MEMORANDUM

SUBJECT: ZC 07-35 *A* – Minor Modification to PUD approved by ZC Order 07-35
Sheridan Terrace Redevelopment
Sheridan Road, SE between Howard Road, SE and Pomeroy Road, SE

Overall Site Plan

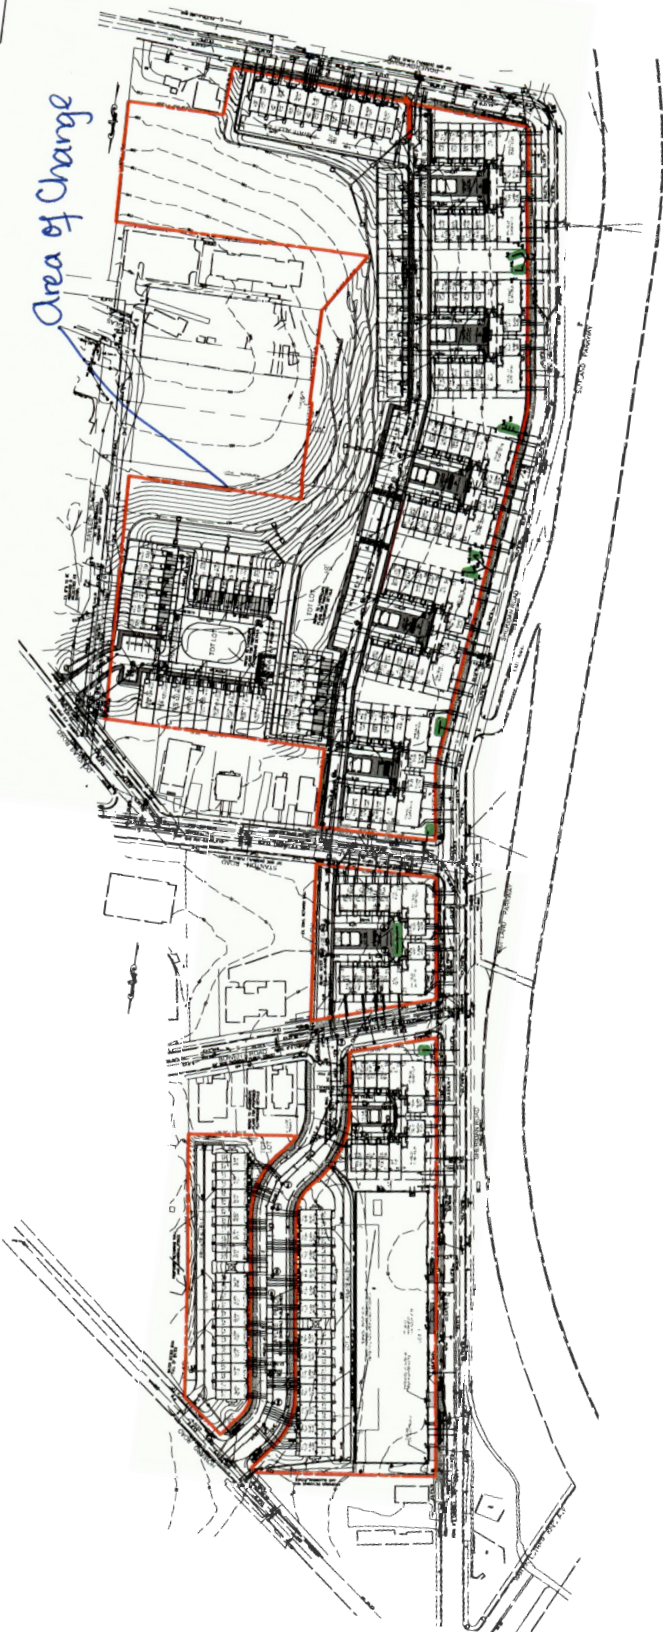
The applicant has recommended two minor modifications to ZC Order 07-35 for the Sheridan Terrace residential development which would affect the boundary of the PUD. Since the approval of the PUD, the applicant has conducted further engineering studies and has determined that adjustments to the PUD boundary are necessary (See attached overall Site Plans).

The first modification involves Lot 956 in Square 5872. Lot 956 was added to the PUD area subsequent to the submission of the application. It has now been determined that the entire lot is not needed to accommodate the proposed retaining walls. The applicant proposes to subdivide Lot 956 into two tax lots, Lot 984 which has the retaining wall and Lot 983 which will be deleted from the PUD. The area of the lot would be reduced from 24,082 square feet to 19,475 square feet (See Exhibit C of the Applicant's Submission).

The second modification involves adding a portion of land, Lot 986 (subdivided from Lot 962 which is outside of the PUD boundary). This additional land is needed to accommodate a portion of a retaining wall and a stormwater management structure which would be located outside the PUD boundary. Lot 986 has an area of 4,136 square feet (See Exhibit D of the Applicant's Submission).
